**Scheme 4: revisions to scheme 3**

REV	DATE	DRN	CHKD
PROJECT	The Hood, Scheme 3 17 Lyndhurst Gardens, Hampstead, London		
CLIENT	Mr and Mrs Yu REPRESENTED BY JAGA Developments (London)		
DRAWING	Sections AA and BB as Proposed		
SCALE	SHEET SIZE	DRAWN	CHECKED
1:50	A0	GM/G	
DATE	Oct 2019

DRAWING NO: **19013** REVISION: **L**  
 STATUS: **PLANNING**

**Section AA: South**

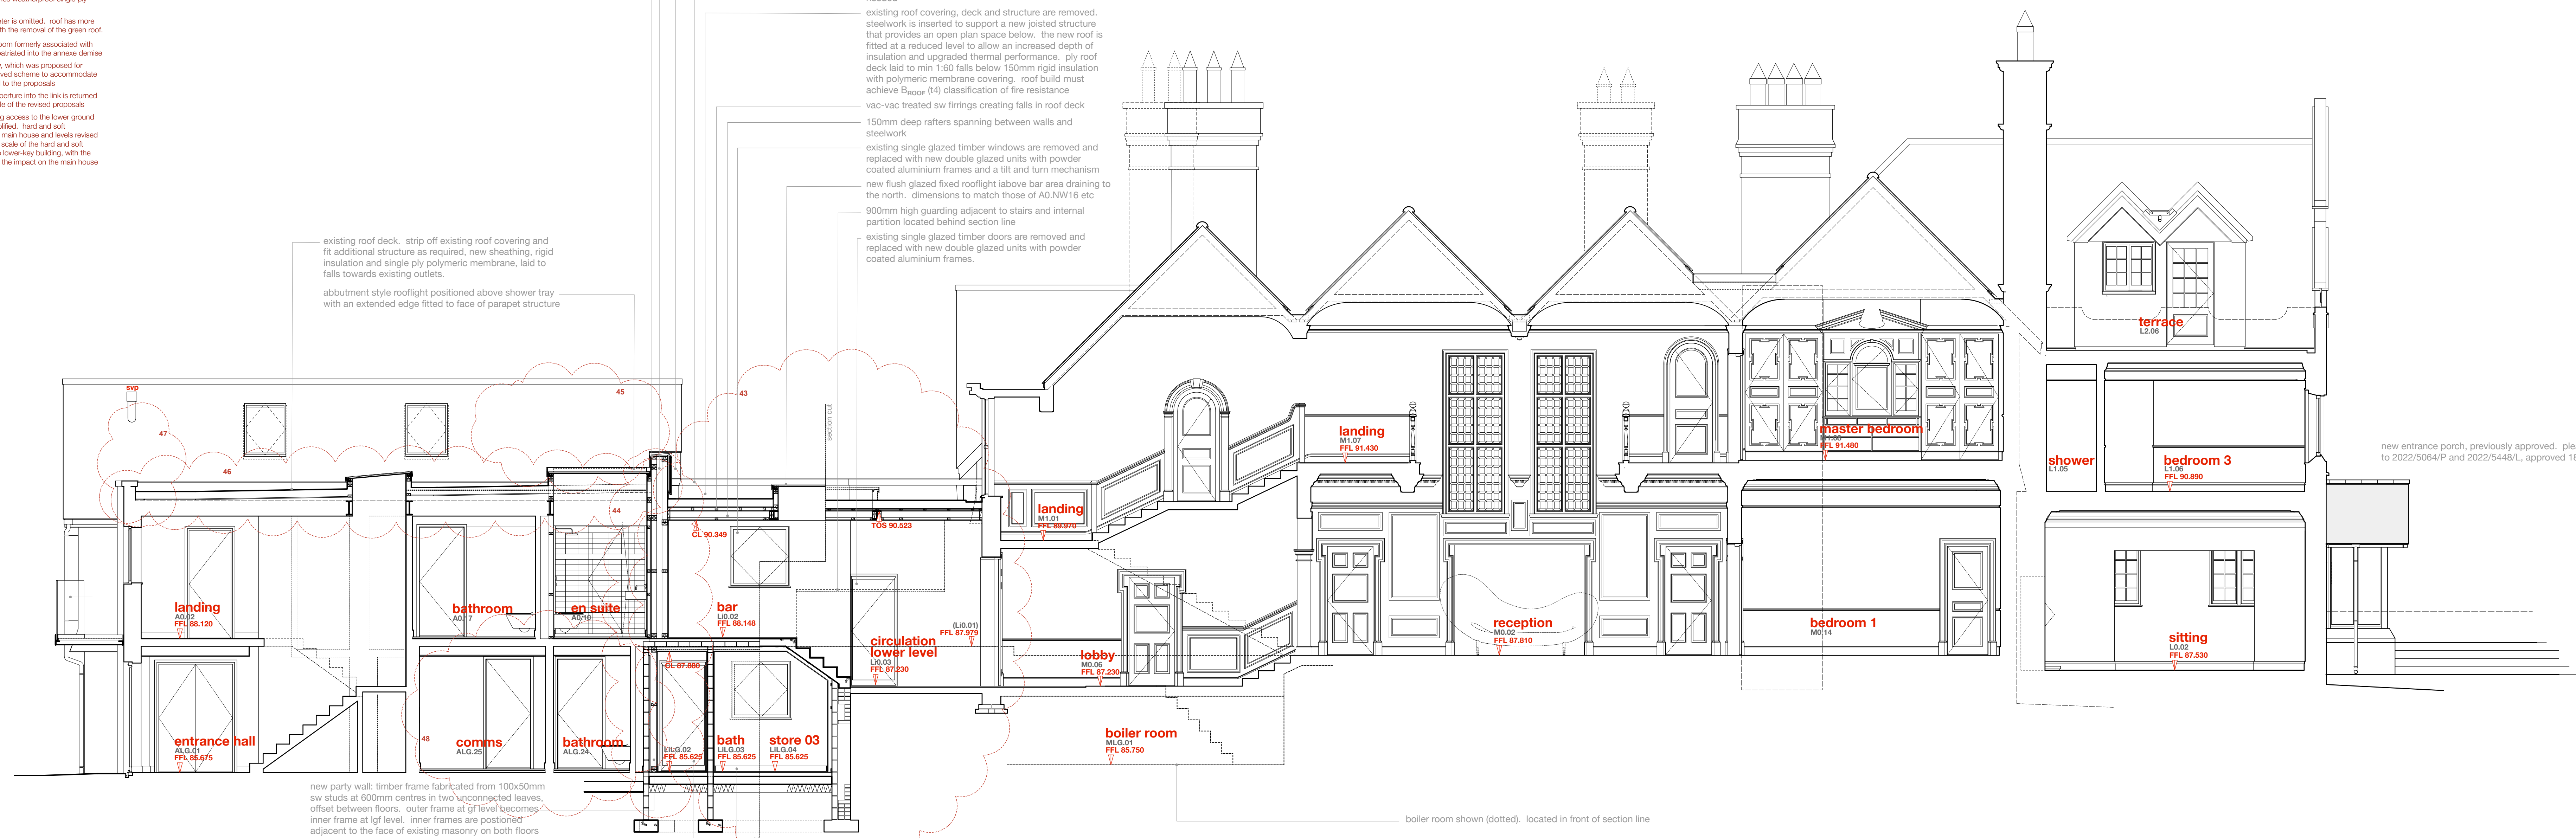
- 43 link: contemporary new-build link and associated serving structures, together with underpinning of the main house and annex that facilitates the development are omitted. The revised scheme seeks to reduce and simplify the design. The volume and structure of the existing building are retained, the existing masonry facades to the north and south are retained. The flat roof and roof structure are removed and replaced with new incorporating improved thermal performance. Single glazed glass roof and south elevation are removed and replaced with new double glazing fixed to powder coated aluminium frames, revised design is naturally ventilated and more energy efficient.

- 44 link: party wall with annex building is simplified and constructed in lightweight timber framing, structural underpinning is no longer retained.
- 45 annex: rooftop dormers containing dormer boxes are omitted.

- 46 annex: green roof is omitted from flat roof, allowing down overall build-up. roof finish becomes waterproof single ply polymeric roof membrane.
- 47 annex: glass guarding at perimeter is omitted, roof has more restricted maintenance access with the removal of the green roof.

- 48 annex: commo room and bathroom formerly associated with the nursery and staff rooms are reallocated into the annex dormer main house. existing bay window, which was proposed for demolition in the previously approved scheme to accommodate the contemporary link, is returned to the proposal.

- 49 main house: opening of former aperture into the link is returned to its original width to suit the scale of the revised proposals.
- 51 link: undercroft structure providing access to the lower ground floor of the redesign link is simplified, hard and soft landscaping is extended from the main house and levels revised to suit the retained structure, the scale of the hard and soft landscaping is reduced to suit the low-key building, with the smaller masses and scales lessening the impact on the main house.
